**GOVERNMENT OF INDIA
MINISTRY OF RAILWAYS
RESEARCH DESIGNS & STANDARDS ORGANISATION
MANAK NAGAR, LUCKNOW - 226 011**

MODIFICATION SHEET NO.RDSO/WAM4/207

Modification in the control circuit of EM Contractors.

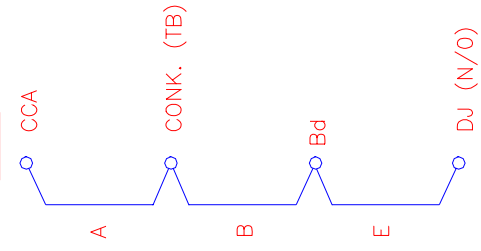
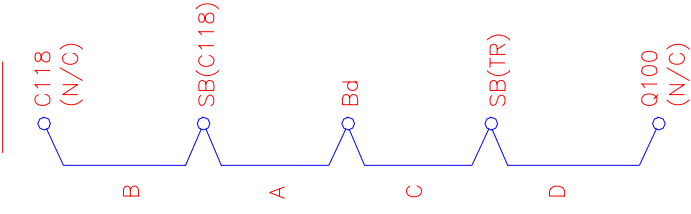
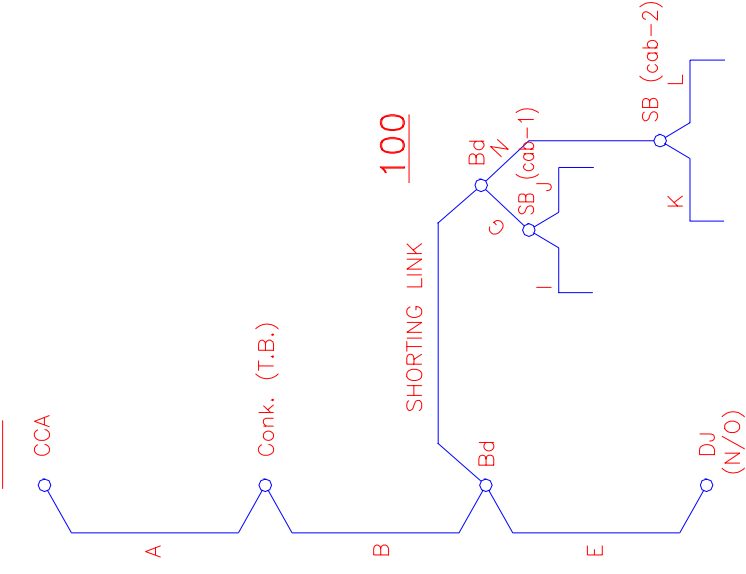
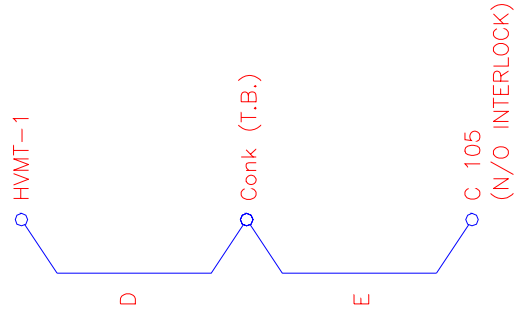
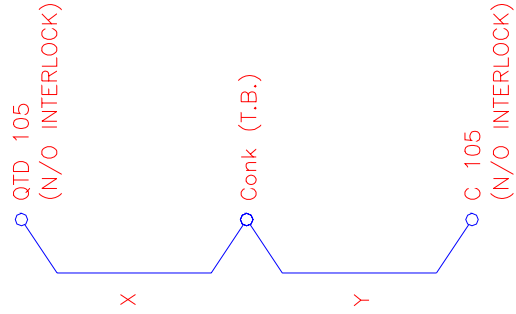
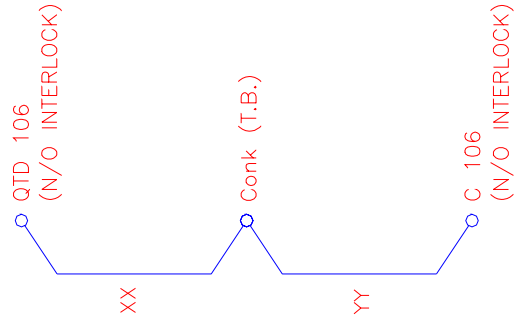
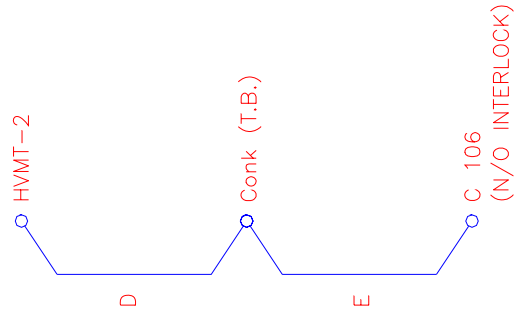
- 2.1 In the existing control circuit of EM contractors in Electric Locomotives supply for Q 100 relay and EM contractors has been taken after the normally open auxiliary contact of DJ and time delayed normally closed auxiliary interlock of C118 contractor. While negotiating the neutral section, drivers normally switch `off` and switch `on` DJ without putting off the BLVMT, BLCP and BLPV switches. As normally open auxiliary interlock of DJ breaks heavy inductive circuit comprising of several EM coils there is a heavy flashover on the DJ auxiliary contact. Therefore regular cleaning of auxiliary contact of DJ is required during schedule maintenance. Also, whenever, there is a case of all auxiliaries not working either due to bad contact in the normally open auxiliary contact of DJ or in the time delayed normally closed contact of C118 contractor, it can not be attended by the driver in the normal course and locomotive has to be failed.

- 2.2 110 V control feed to the coils of C105 and C106 contractors have been given through normally open contact of QTD 105 and normally open contact of QTD 106 relays respectively. As reported by various Railways, there have been cases on line when due to some reasons or the other the normal open interlocks of QTD 105 and QTD 106 malfunctions resulting in heavy flashover at C105 and C106 contractors and some times burning of MVMT1 and MVMT2 due to single phasing.

- 2.3 The proposed modification attends both the above described problems.

The existing control circuit of EM contractors is to be modified as shown in the Annexure-I. The details of cable index are given in Annexure-II.

EXISTING CABLE CONNECTIONS

MODIFIED CABLE CONNECTIONS

NEW CABLE CONNECTIONS TO BE DONE
